Access Compliance Report Public Rights-of-Way (Curb Ramps)

Main Street: NORWOOD_PKWY **Cross Street:** HOLT_AVE **Location:** NE

ADA ID: RPAT211004133650 **Ramp Type:** Type 6 - Directional 1 **Initial Pass/Fail:** Pass **Overall Compliance:** No **Severity Score:** 6

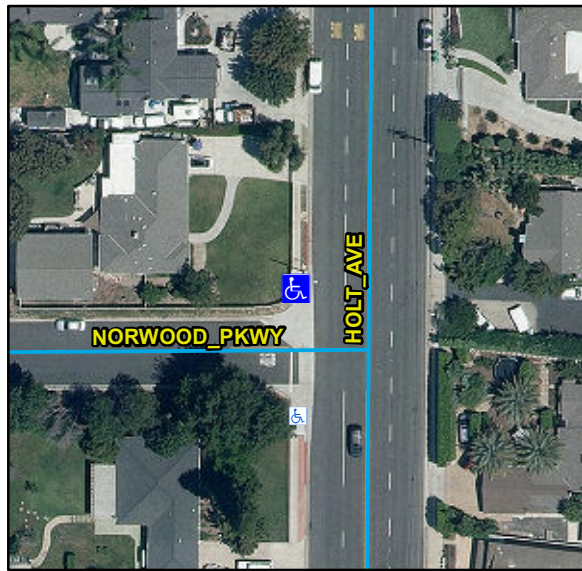
Possible Solutions:
Remove & Replace Entire Ramp.

OC Std/PROW:
R304.2.1, R304.2.2-Perp, R304.3.2-Para, R305.2, STD 1115
